ITW Building Components Group, Inc.

Truss Fabricator: Anderson Truss Company
Job Identification: REPAIR/7-227
Truss Count: 3
Model Code: Florida Building Code 2004 and 2006 Supplement
Truss Criteria: ANSI/TPI-2002(STD)/FBC
Engineering Software: Alpine Software, Version 7.37.
Structural Engineer of Record: The identity of the structural EOR did not exist as of
Address: the seal date per section 61G15-31.003(5a) of the FAC
Minimum Design Loads: Roof - 40.0 PSF @ 1.25 Duration
Floor - N/A
Wind - 110 MPH ASCE 7-02 -Partially Enclosed

#	Ref	Description	Drawing#	Date
1	33148--H17A		08022001	01/22/08
2	33148--H15A		08022002	01/22/08
3	33148--A1		08022003	01/22/08

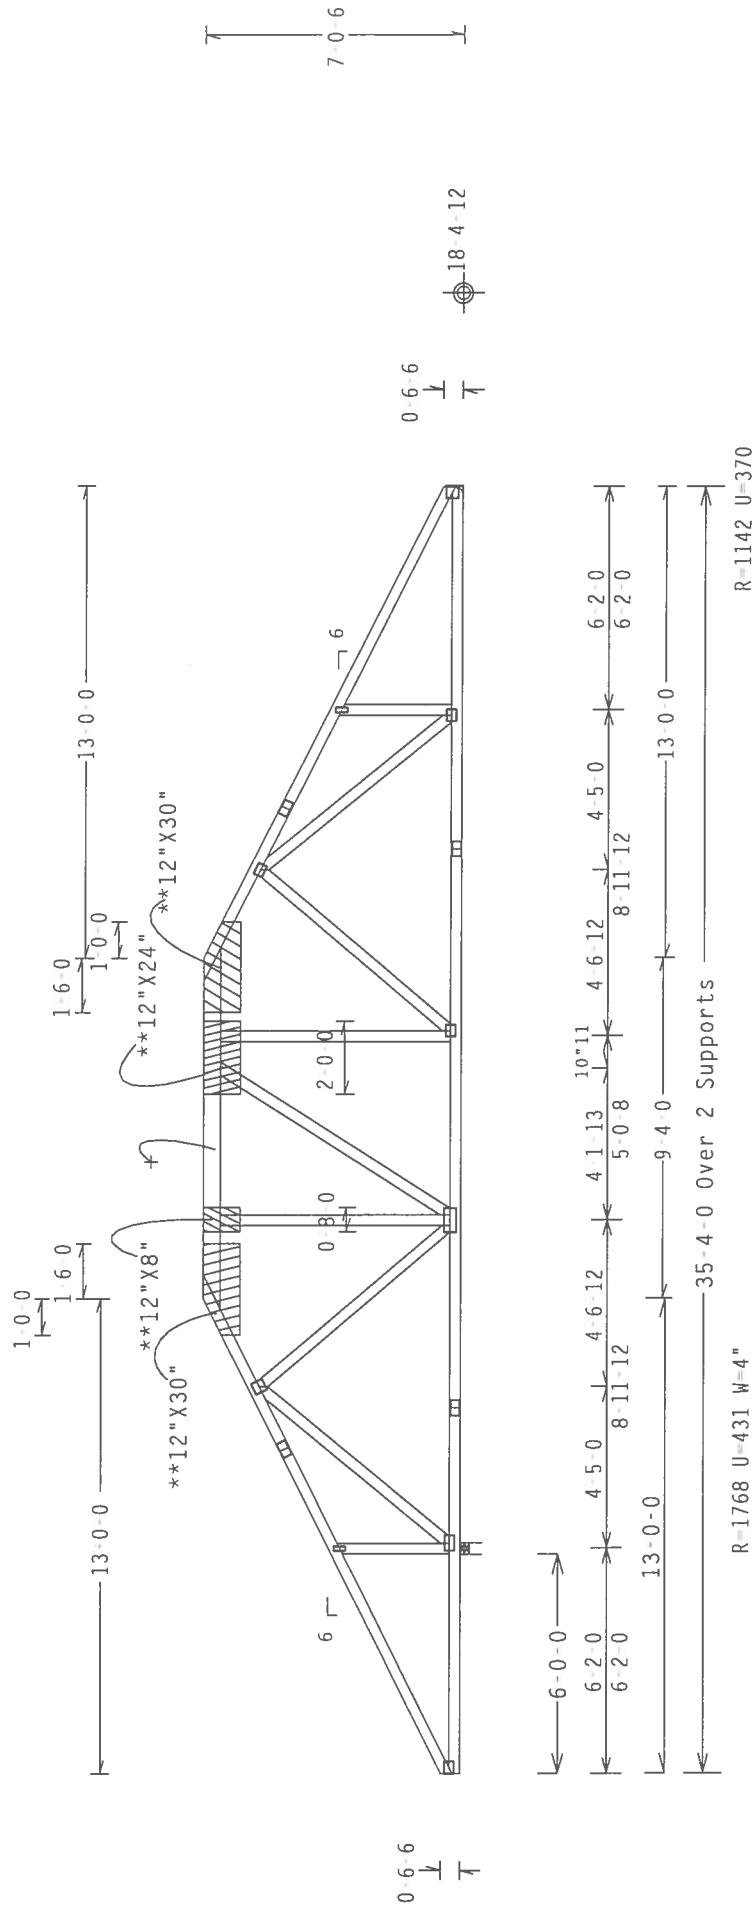
This truss is repaired to create a 13' top chord set back from each end as shown.

Refer to drawing HCUSR8228 07221022 for plates and other data not given here.

++ USE A CARBIDE TIP SAW BLADE TO CAREFULLY REMOVE UNWANTED PORTION OF TRUSS. REMAINING PORTIONS OF TRUSS AND ALPINE PLATES MUST REMAIN INTACT & FREE FROM DAMAGE.

** (2) NEW 3/4"X(SIZE SHOWN) TRIMMED TO FIT APA SPAN RATED 40/20 SHEATHING (PLYWOOD OR OSB) . ATTACH ONE GUSSET TO EACH FACE OF THE TRUSS WITH 2 ROWS OF 0.113"x2.0" NAILS SPACED 2" OC STAGGERED THROUGHOUT ALL MEMBERS, WITHOUT SPLITTING THE LUMBER.

+ FIELD APPLIED 2X6 SP #2 (OR BETTER) NEW TOP CHORD.
CUT TO FIT TIGHT.

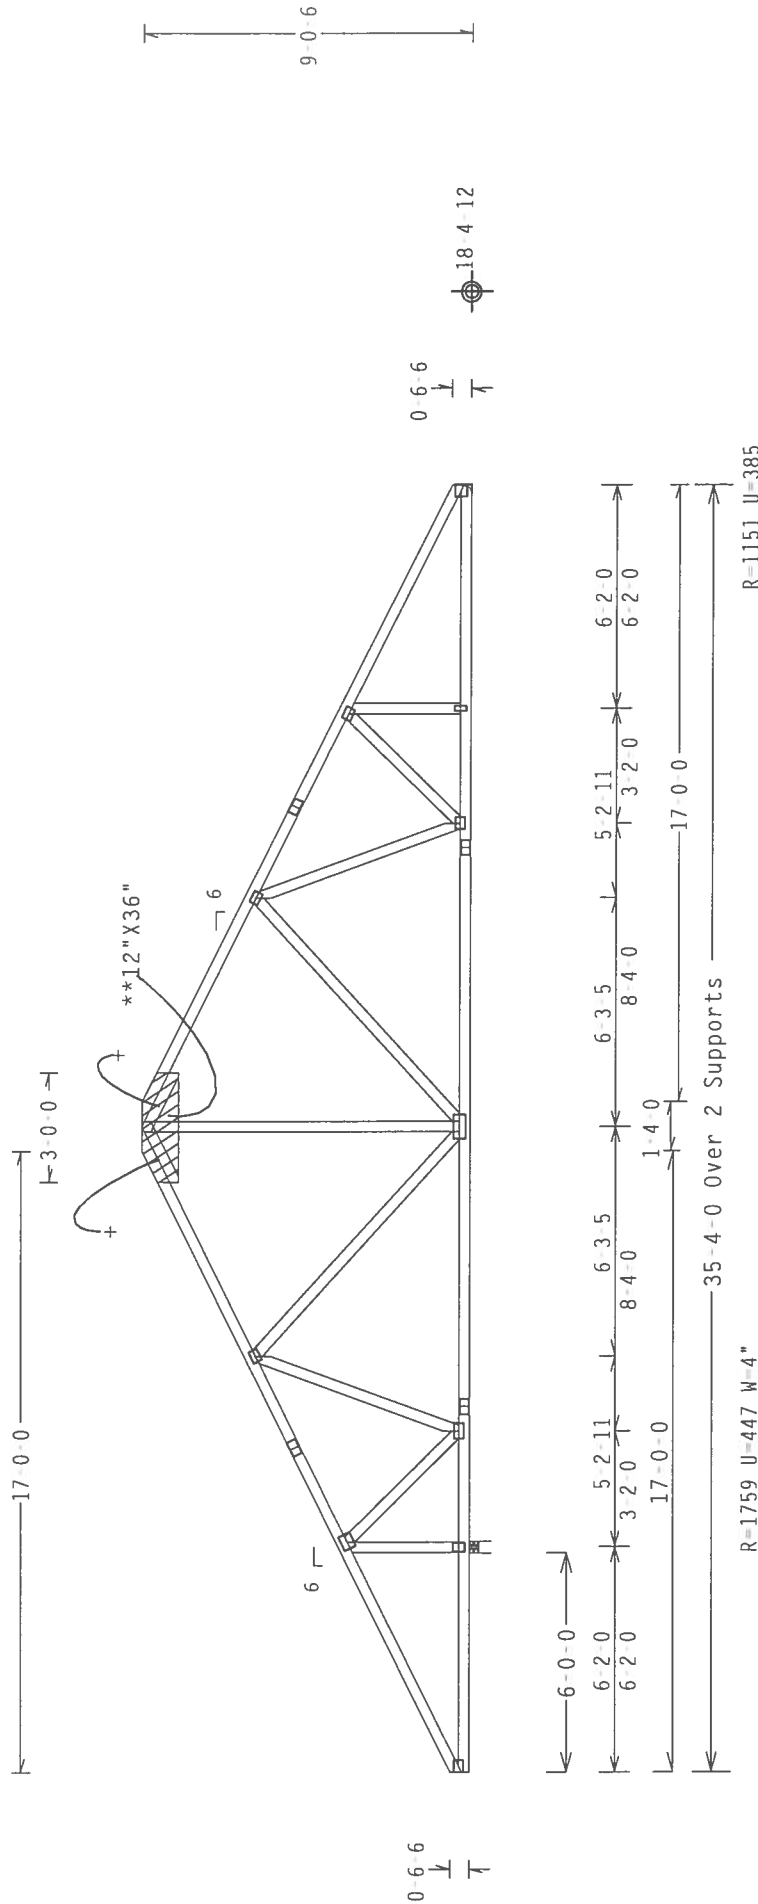
This truss is repaired to create a 17' top chord set back from each end as shown.

Refer to drawing HCUSR8228 07221024 for plates and other data not given here.

+ FIELD APPLIED 2X4 SP #2 (OR BETTER) NEW MEMBERS. CUT TO FIT TIGHT. NOTE TWO NEW MEMBERS STACKED UNDER TOP CHORD.

** (2) NEW 3/4"X(SIZE SHOWN) TRIMMED TO FIT APA SPAN RATED 40/20 SHEATHING (PLYWOOD OR OSB). ATTACH ONE GUSSET TO EACH FACE OF THE TRUSS WITH 2 ROWS OF 0.113"X2.0" NAILS SPACED 2" OC STAGGERED THROUGHOUT ALL MEMBERS, WITHOUT SPLITTING THE LUMBER.
